PROJECT NUMBER: 001186 (1008660)  
 Application Number: SI-2018-00043

REV	DATE	DESCRIPTION
1	05/05/2023	ADMINISTRATIVE AMENDMENT
	11/11/2019	PER URT AND DRB COMMENTS
	08/09/2018	SUBMIT TO UPTOWN REVIEW TEAM
	05/16/2018

McDonald's USA, LLC  
 110 N. CARPENTER ST., CHICAGO, IL 60607  
 MCDONALD'S U.S. CHICAGO, IL 60607  
 5000 MENAUL BLVD. NE  
 ALBUQUERQUE, NM

SITE DEVELOPMENT PLAN  
 SITE PLAN  
**SDP-1**

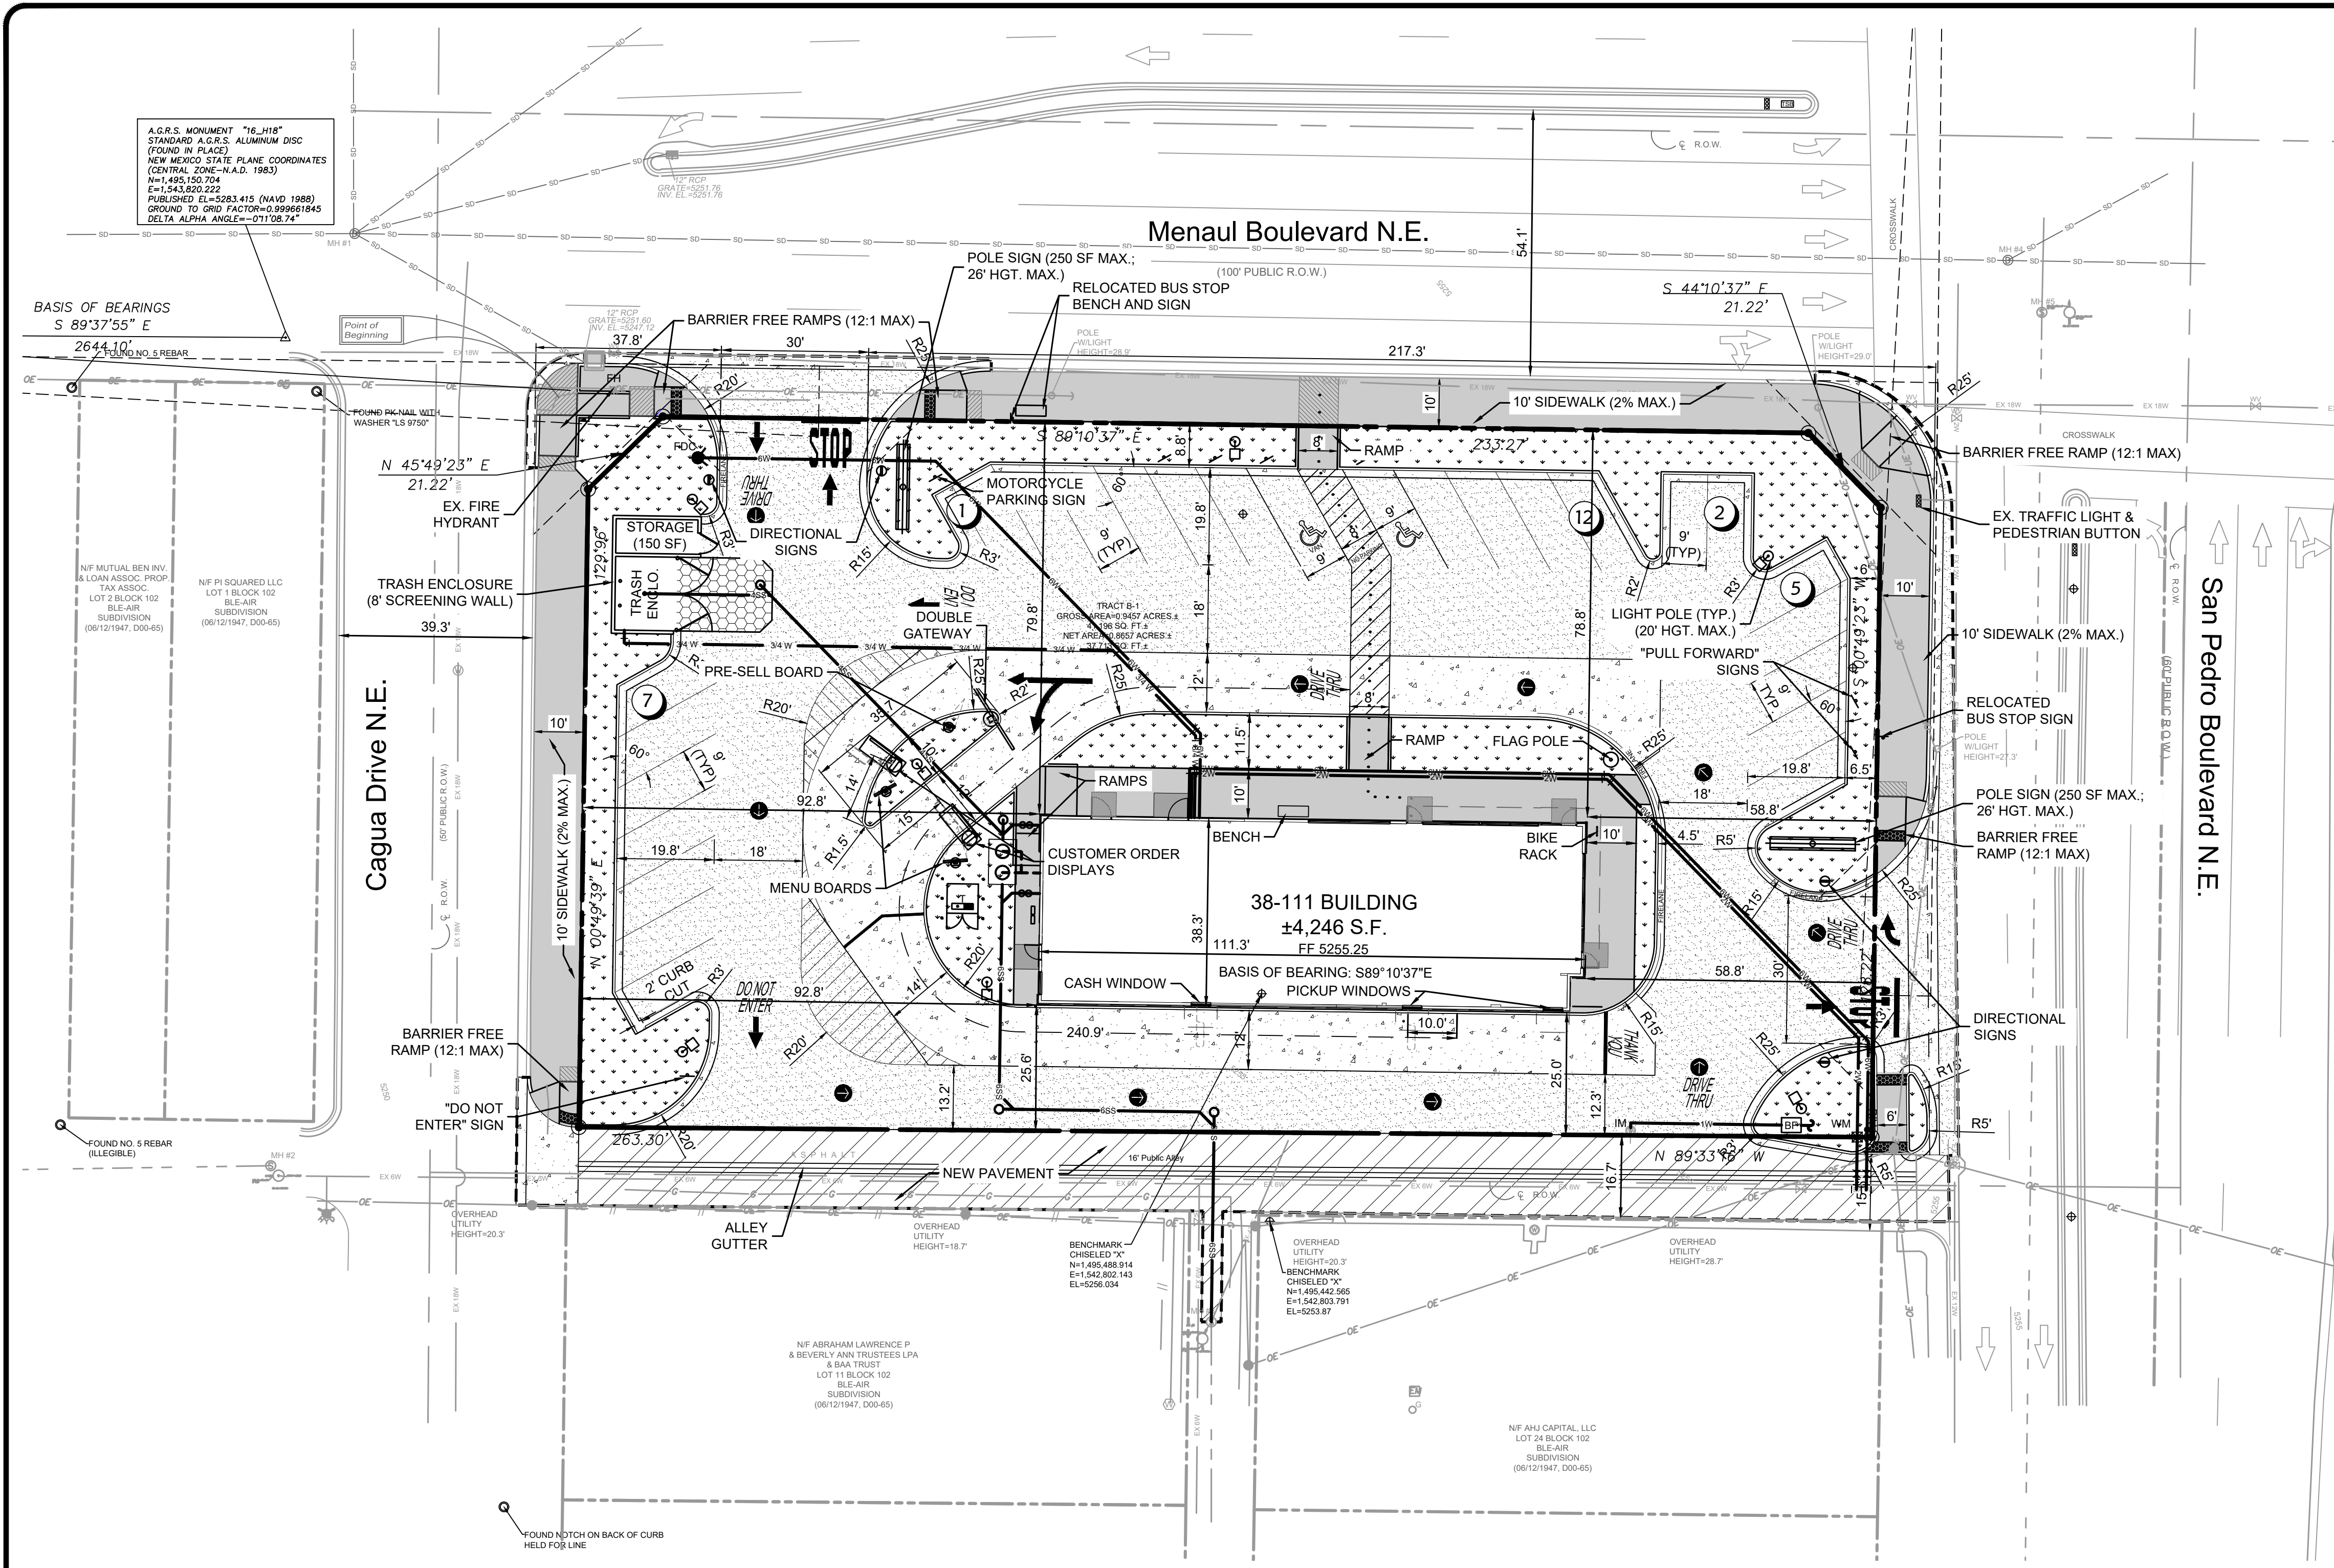
- MOVED BUILDING NORTH 12' PER TRANSPORTATION DEPARTMENT COMMENTS AND ELIMINATED A ROW OF PARKING STALLS.
- SHORTENED PARKING STALLS PER CURRENT DEVELOPMENT PROCESS MANUAL.
- SHIFTED SOUTHEAST DRIVEWAY NORTH 10' PER TRANSPORTATION DEPARTMENT COMMENTS.
- SHIFTED SAN PEDRO BLVD. NE ROW LINE WEST TO ALLOW ROOM FOR A BIKE LANE.

SITE DEVELOPMENT PLAN  
LANDSCAPE PLAN

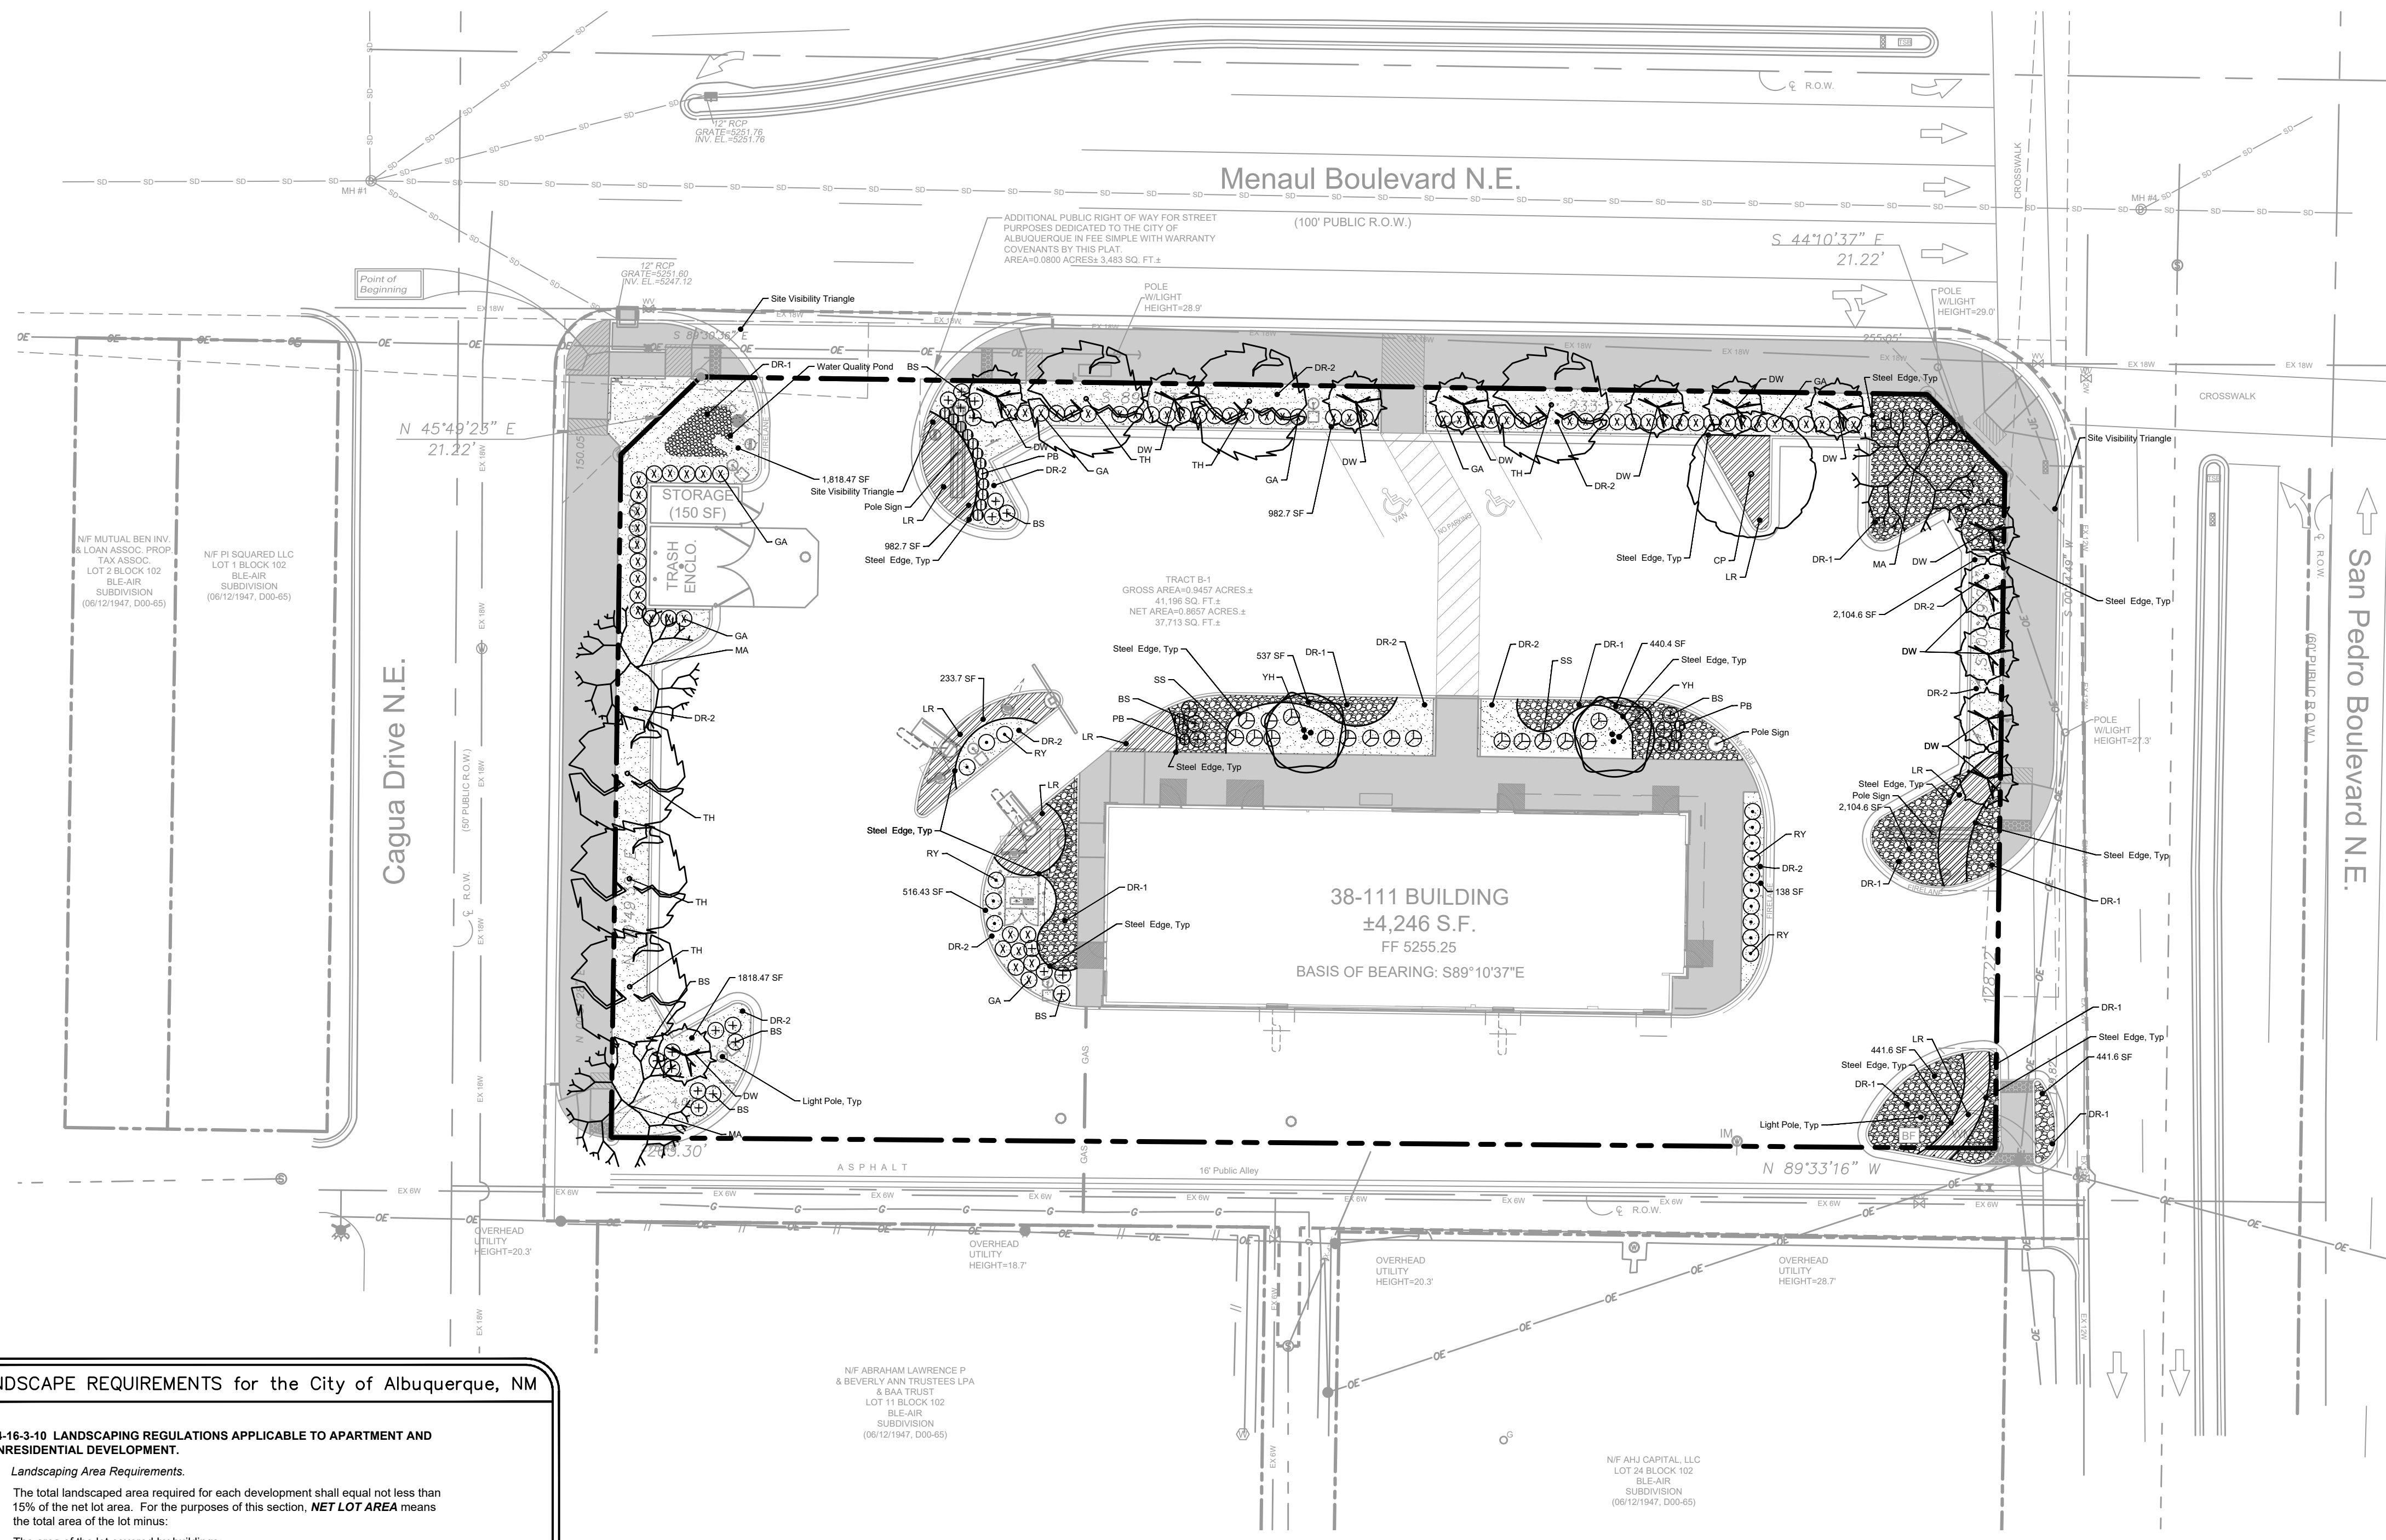
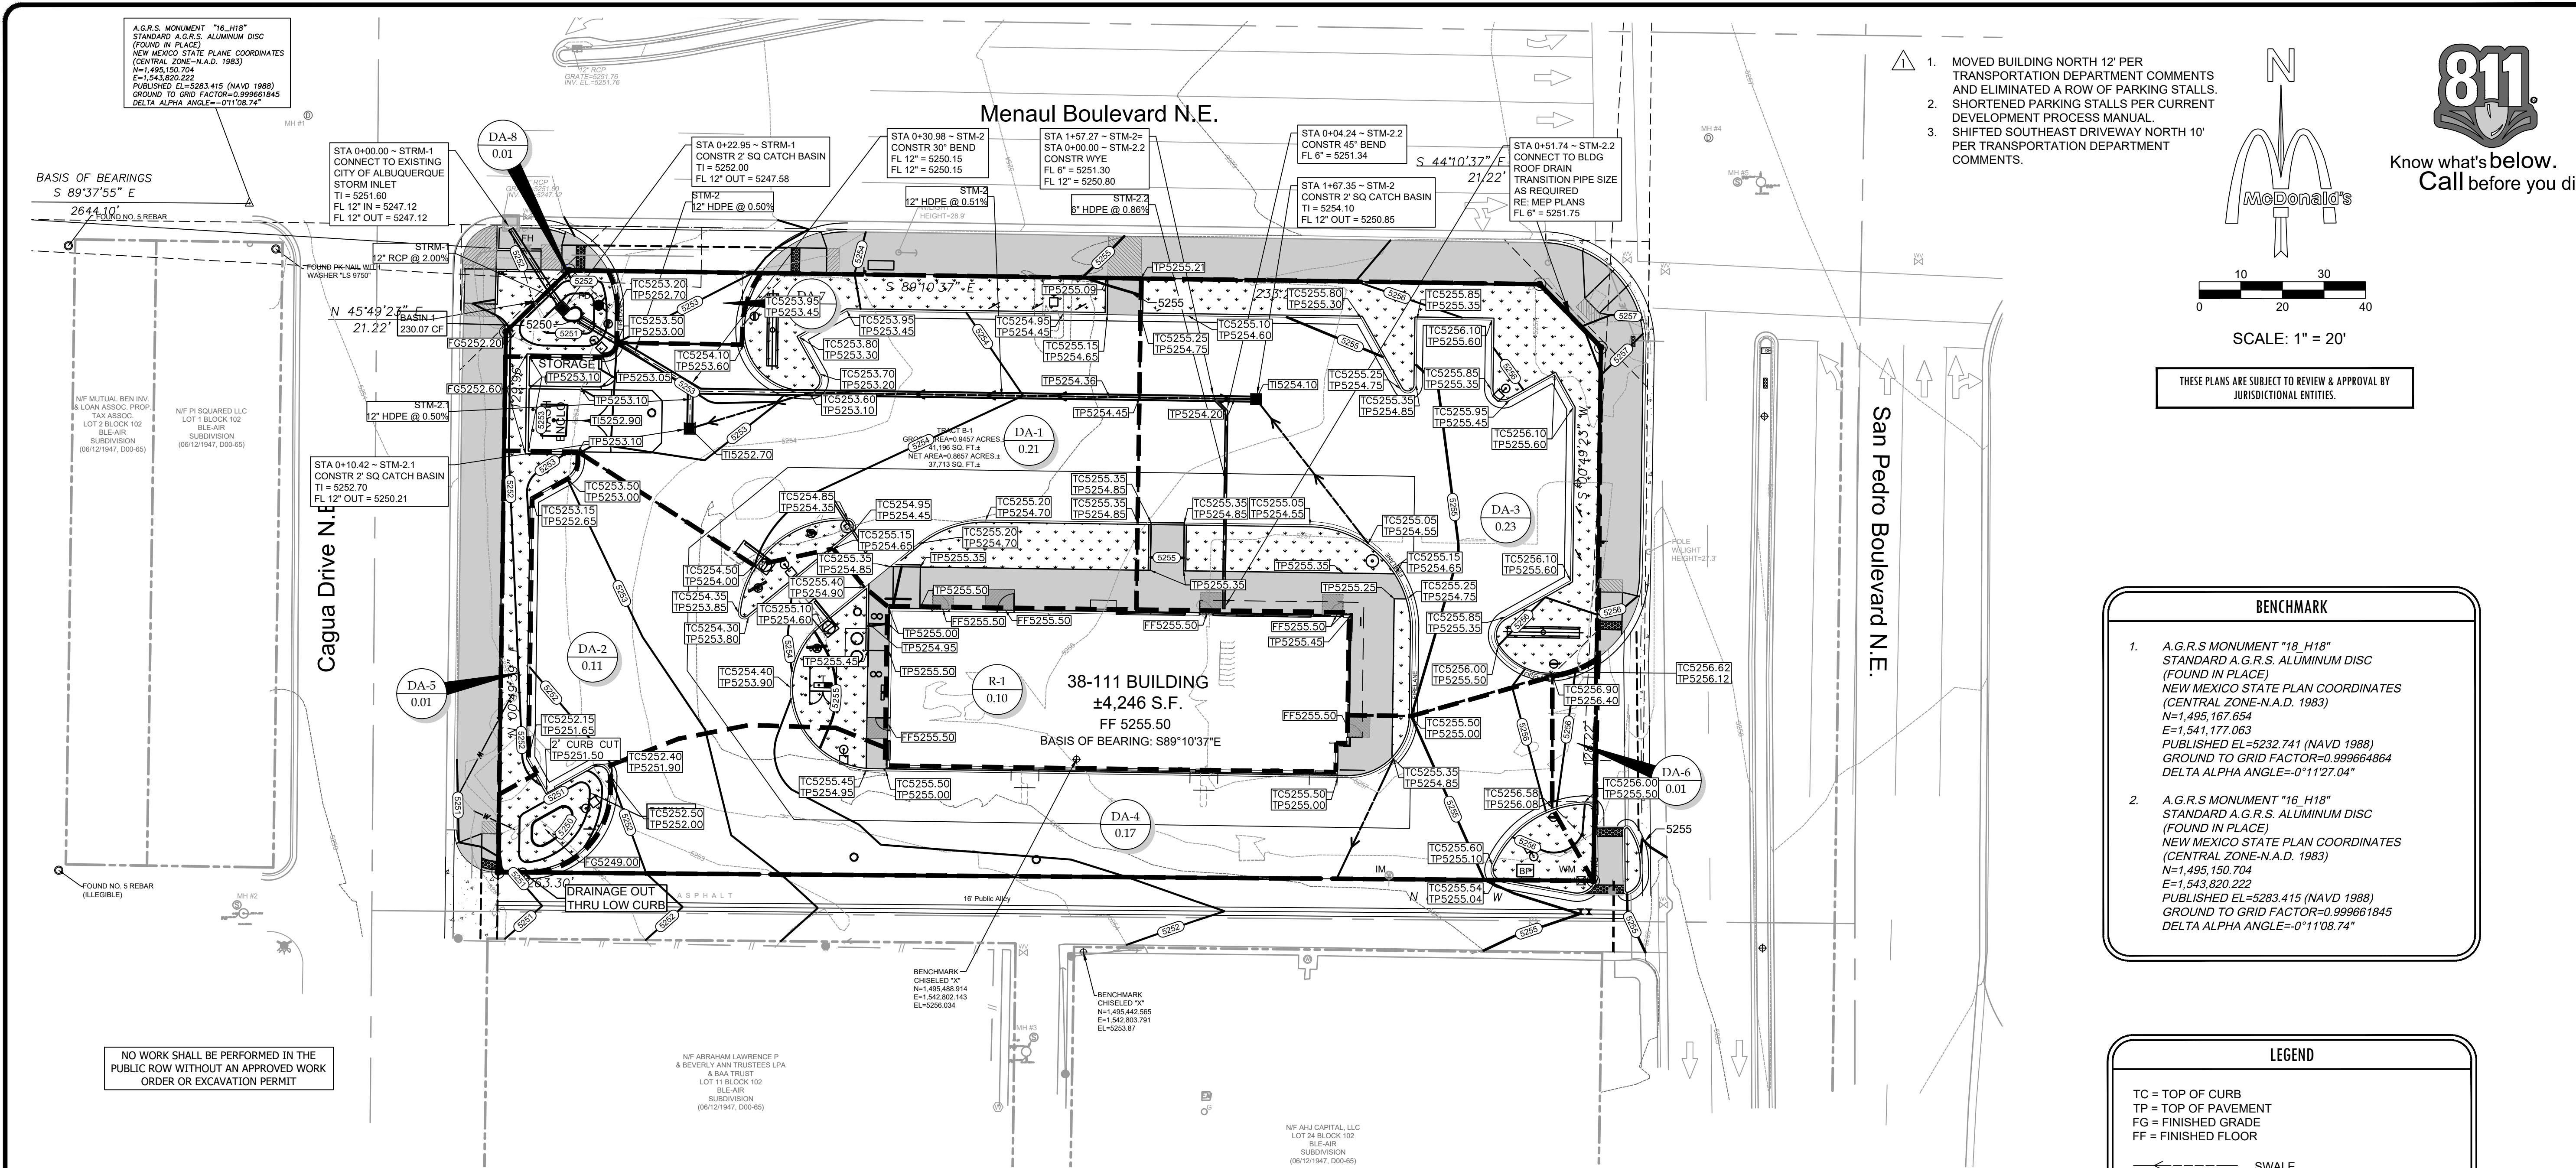
- MOVED BUILDING NORTH 12' PER TRANSPORTATION DEPARTMENT COMMENTS AND ELIMINATED A ROW OF PARKING STALLS.
- SHORTENED PARKING STALLS PER CURRENT DEVELOPMENT PROCESS MANUAL.
- SHIFTED SOUTHEAST DRIVEWAY NORTH 10' PER TRANSPORTATION DEPARTMENT COMMENTS.
- SHIFTED SAN PEDRO BLVD. NE ROW LINE WEST TO ALLOW ROOM FOR A BIKE LANE.
- ADJUSTED LANDSCAPE AROUND BUILDING AND ALONG SAN PEDRO DUE TO SITE CHANGES.
